Meeting: 7/16/2026
Applicant: Jason Strange, Young Home Buyers
Owner: Highland Haven Orange LLC

Location: 1726 Washington Ave. **Parcel ID:** 82 P G 007
District: Edgewood-Park City H
Zoning: RN-2 (Single-Family Residential Neighborhood)
Description: Craftsman, c.1910

7-A-26-HZ
APPLICATION FOR CERTIFICATE OF APPROPRIATENESS

1726 Washington Ave. 37917
 Edgewood-Park City H

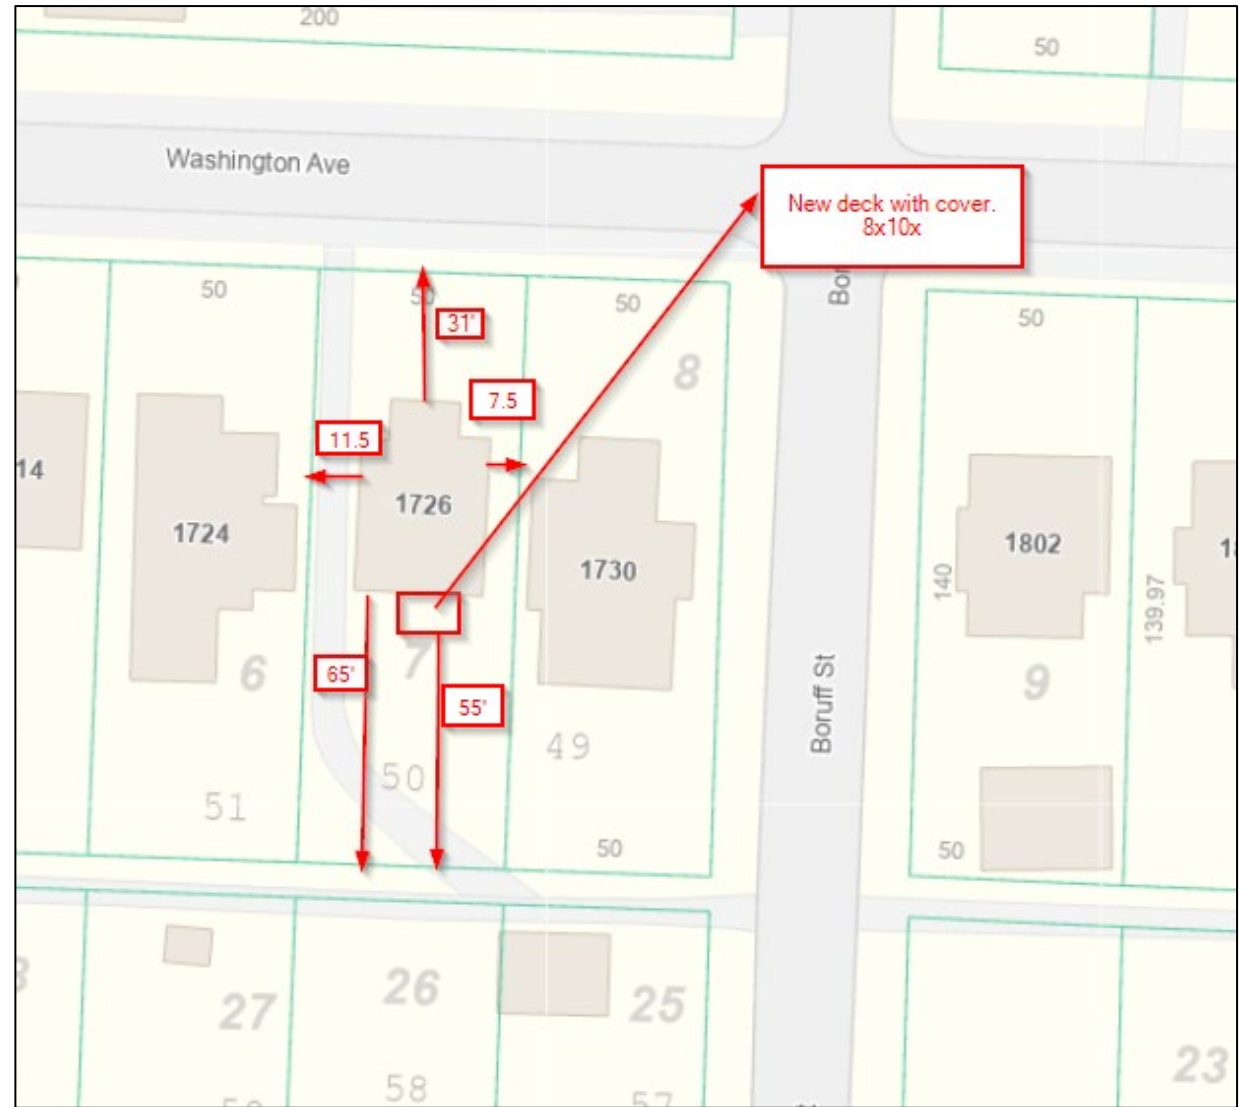
4. The wood lap siding is deteriorated or broken in places. Guidelines recommend repairing and replacing siding materials “with components that match the original in material, dimension, detail, profile, and texture,” and allow for smooth-finished fiber cement boards as a replacement only when the wood has deteriorated beyond repair. Much of the existing wood siding is intact, and LP Smart Siding may not replicate the dimension, detail, and profile of the existing wood. Patching in LP Smart Siding boards with existing wood siding is not appropriate within the design guidelines; any rotten/missing wood siding should be replaced with wood boards.

D1 | DECK FRAMING PLAN

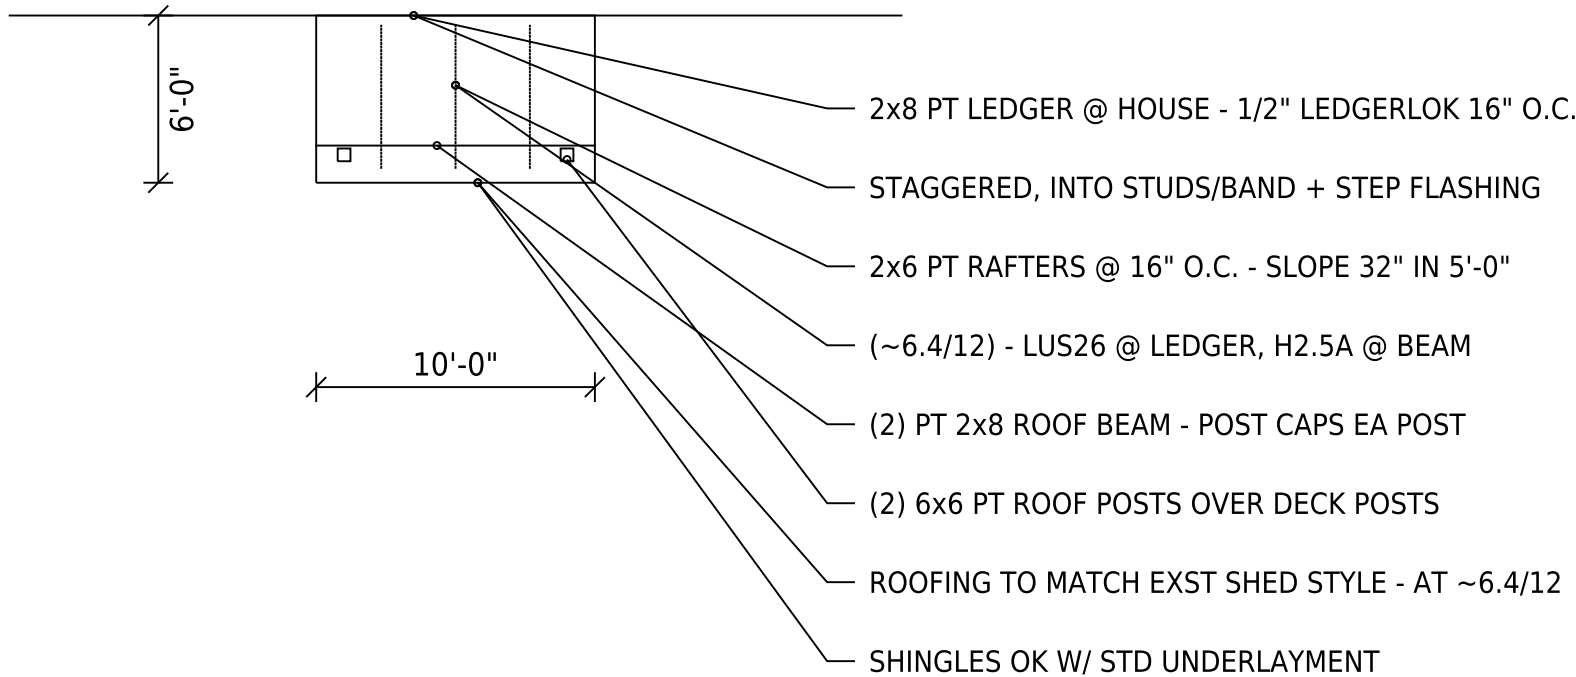
6. A new wood deck in the dimensions and materials proposed meets the design guidelines. The deck railing should feature balusters set into the top and bottom rails. A new shed roof on the rear elevation is appropriate within the guidelines, though the applicant should submit additional details on the roof’s pitch and materials to staff for review.

Staff recommends approval of Certificate 7-A-26-HZ, subject to the following conditions: 1) all wood lap siding to be replaced in-kind, with boards matching the original material, dimension, detail, and profile; 2) additional details on porch roof repair and reconstruction to be submitted to staff for approval (with any major repair or replacement to be delegated to the HZC for review), with new shingles to be compatible in style, scale, and material with the house; 3) additional information on rear deck roof's materials and pitch to be submitted to staff for review; 4) deck balusters to be set into the top and bottom rails.
